Re: Cherokee Nation WW Hastings Replacement Hospital - Addendum 02 Narrative

Following is a list of revisions included in Addendum 02.

PROJECT PHASE:
BID PACKAGE 02
(SITE DEMOLITION AND UTILITIES)

C6-102

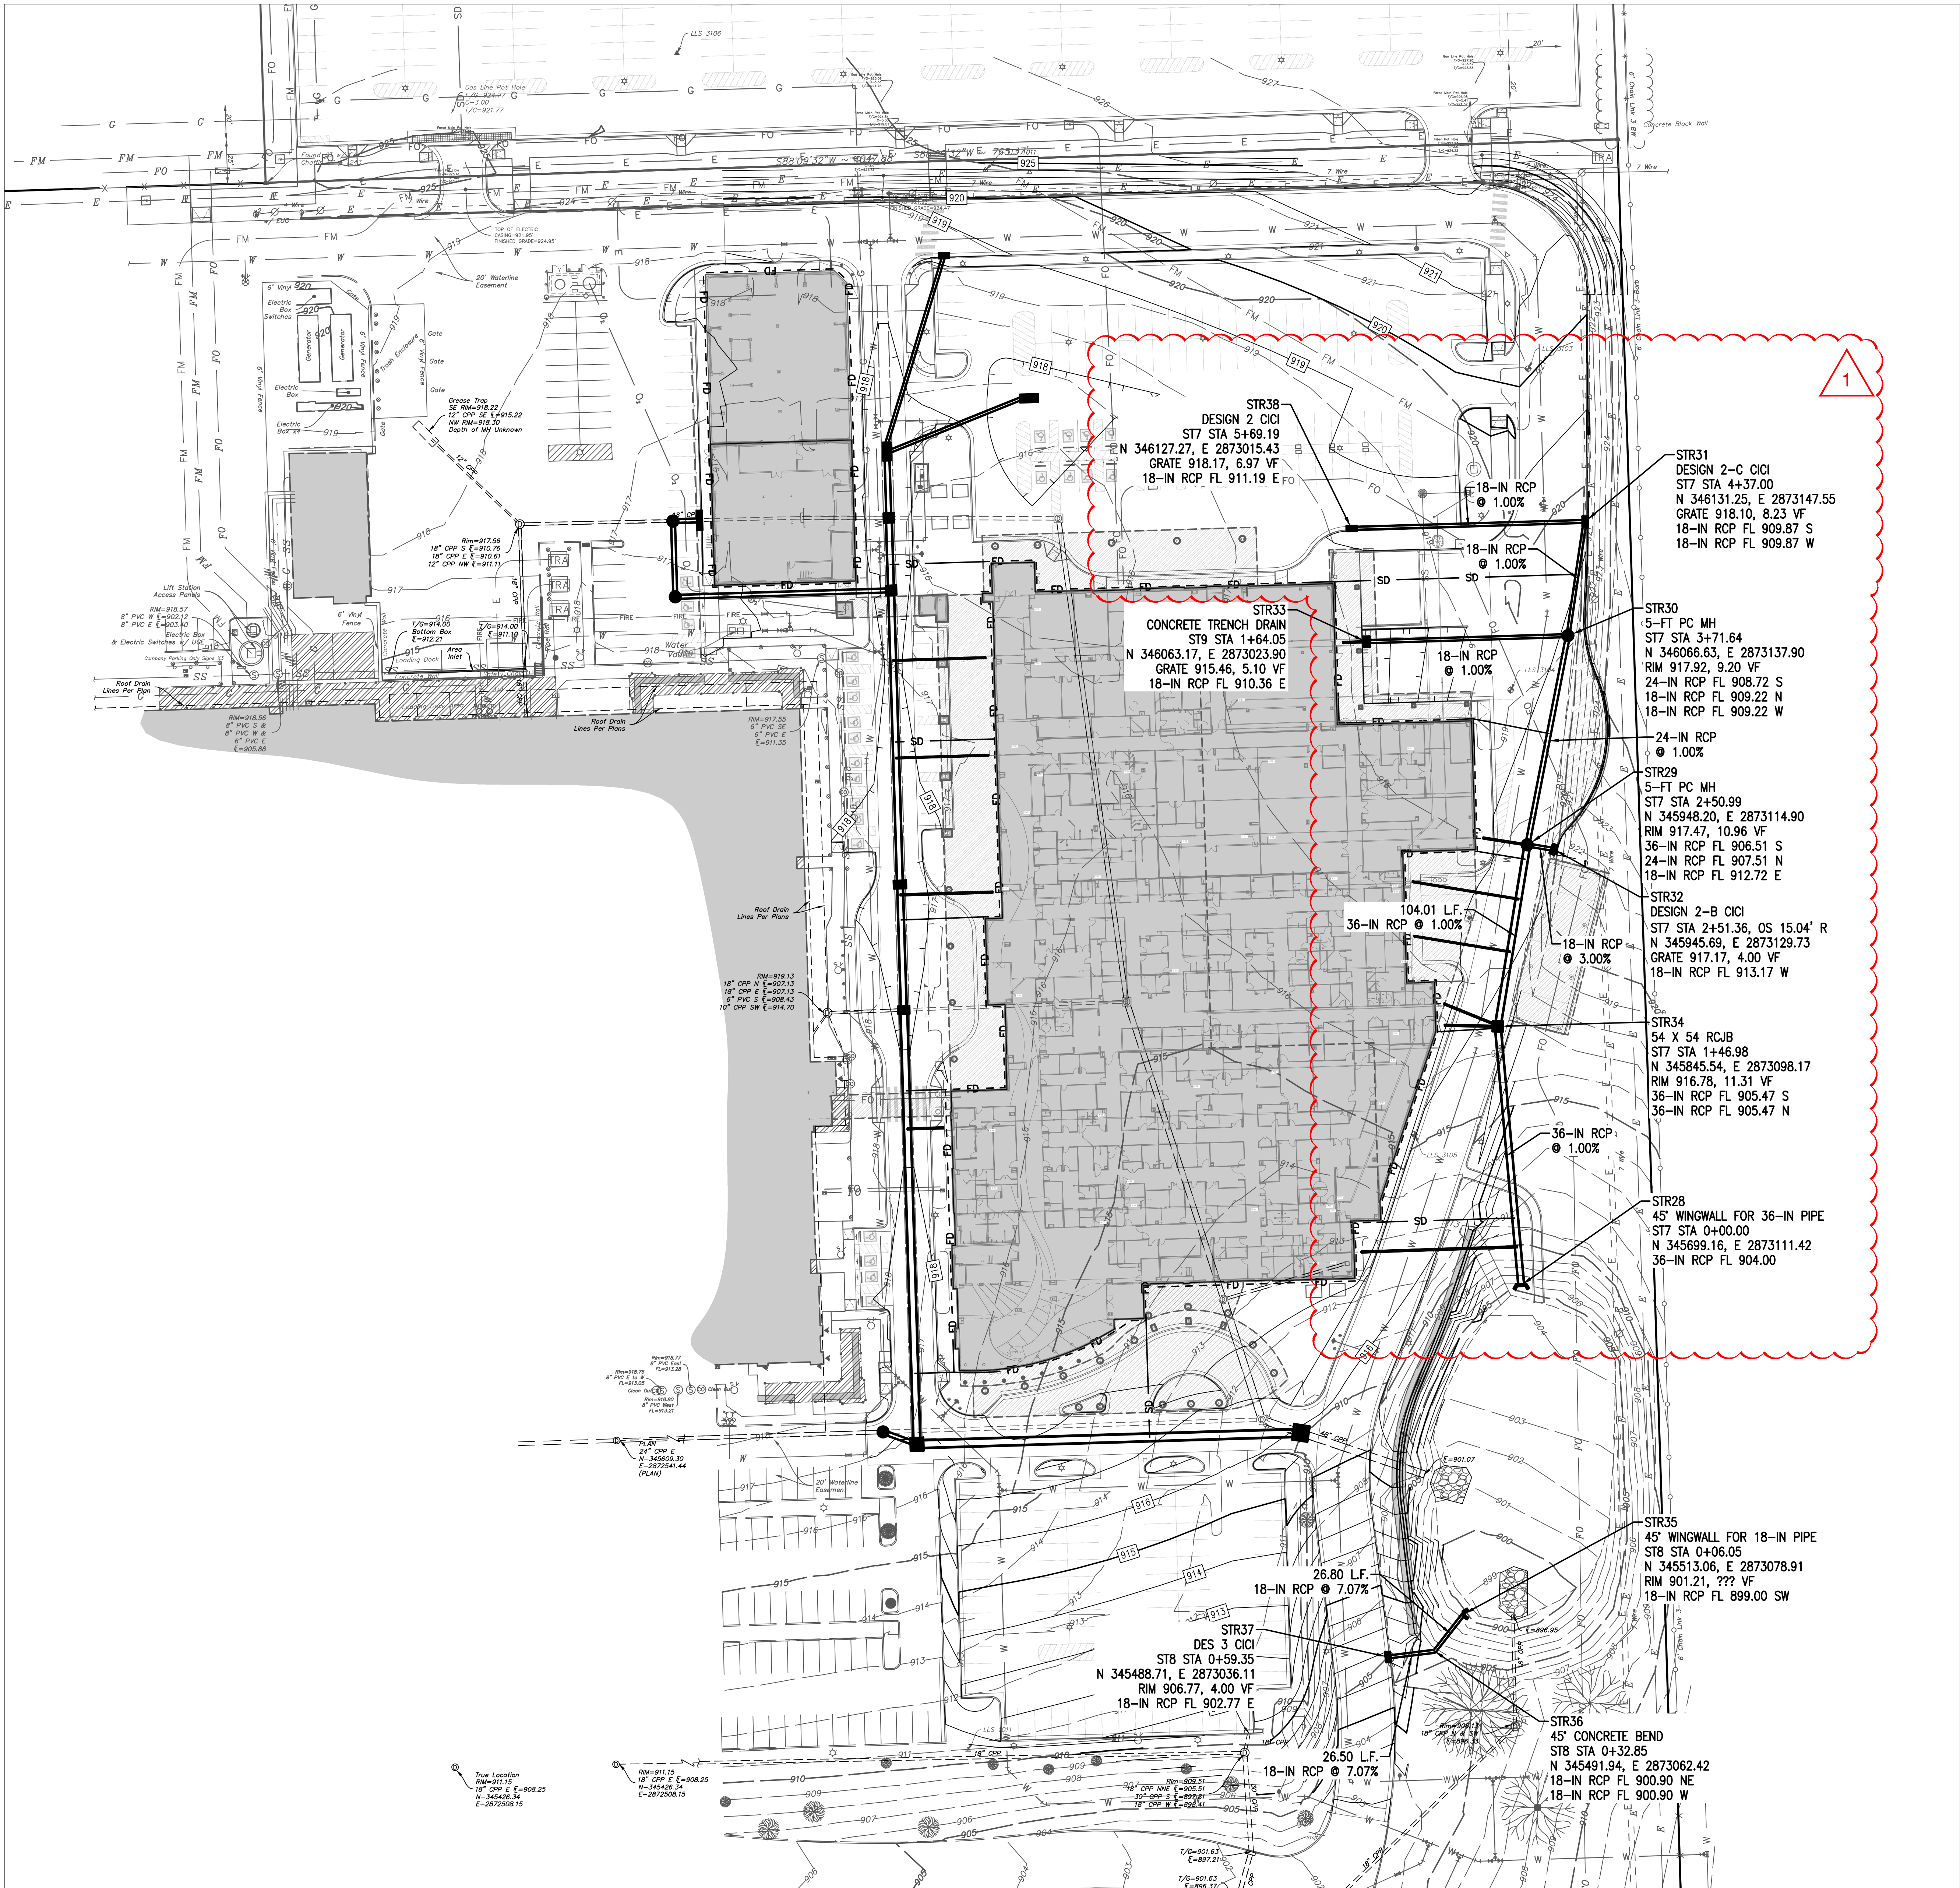
- C6-101 - Corrected grate elevation on STR9.
Corrected STR22 to connect the existing storm sewer pipe to the manhole.
- C6-102 - Added STR38 inlet north of the hospital.
The flow lines of the pipes from STR28 to STR31 were lowered so that drainpipes on the upstream end can pass under the 16-in water line.

C6-103

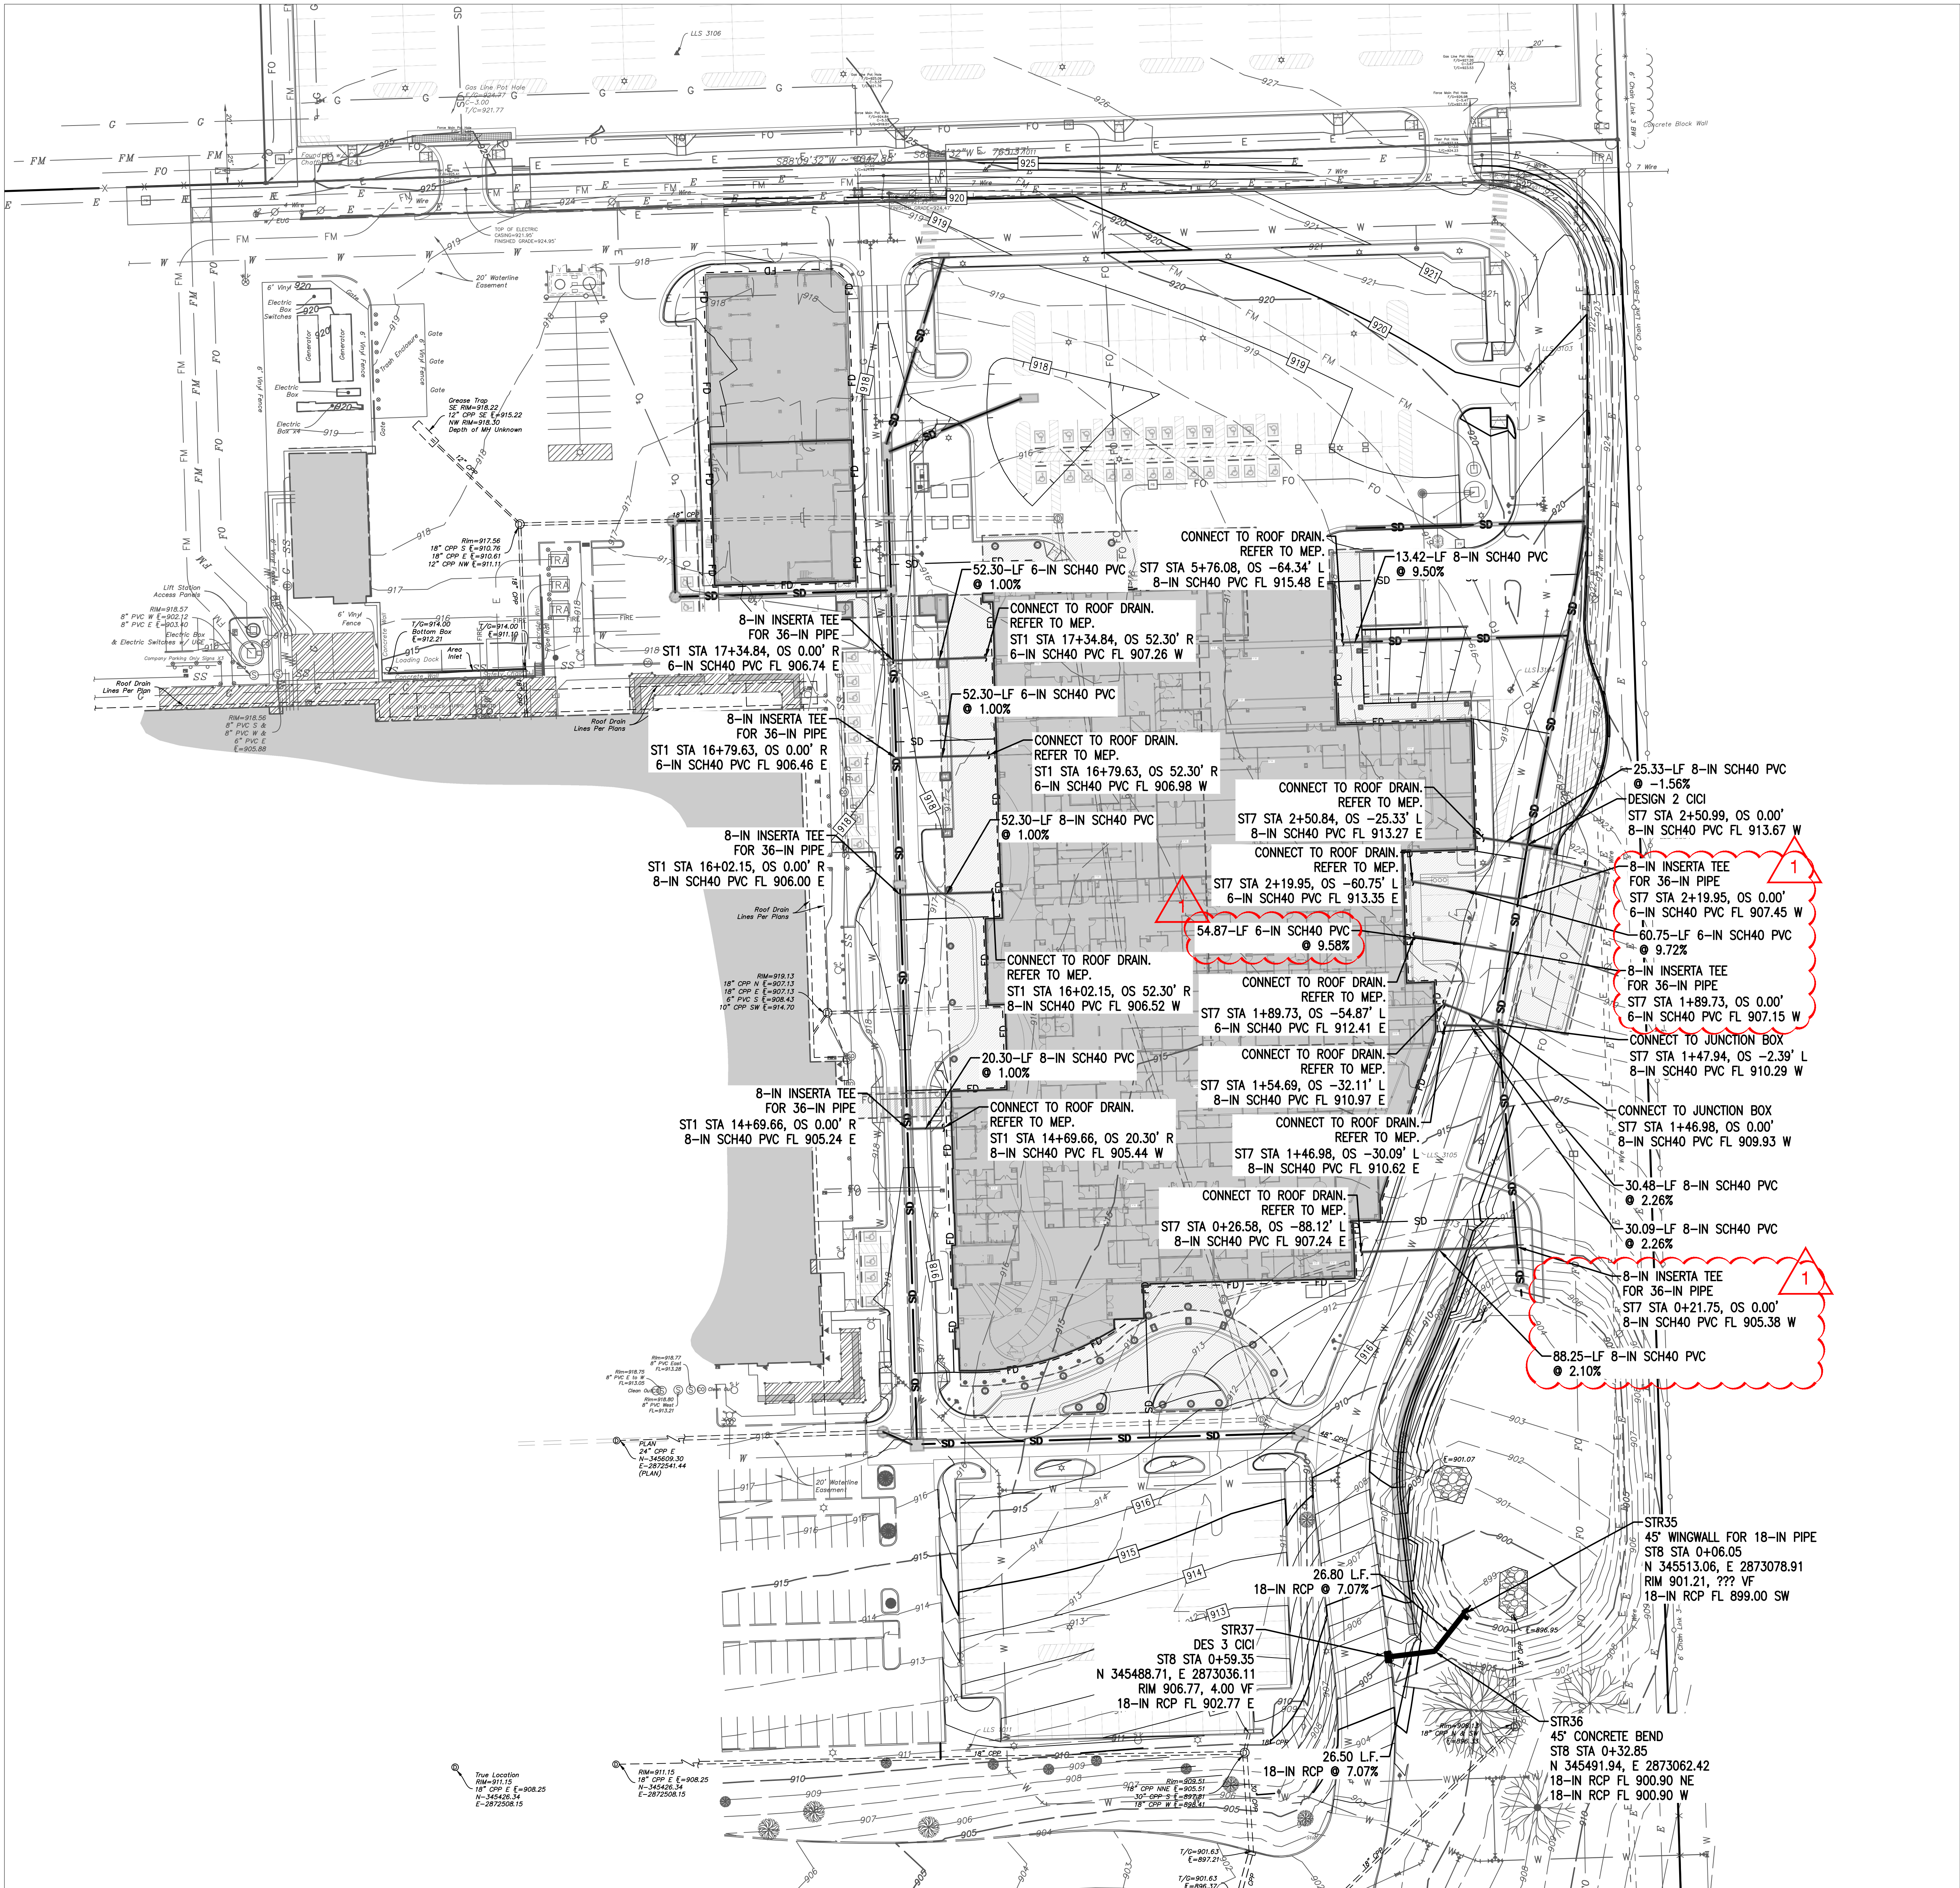
- C6-103 - Revised pipe connections to storm sewer for the lower storm sewer.
- C6-203 - Added label to STR18.
Corrected STR22 to connect the existing storm sewer pipe to the manhole.
Existing water line shown in profile ST5.
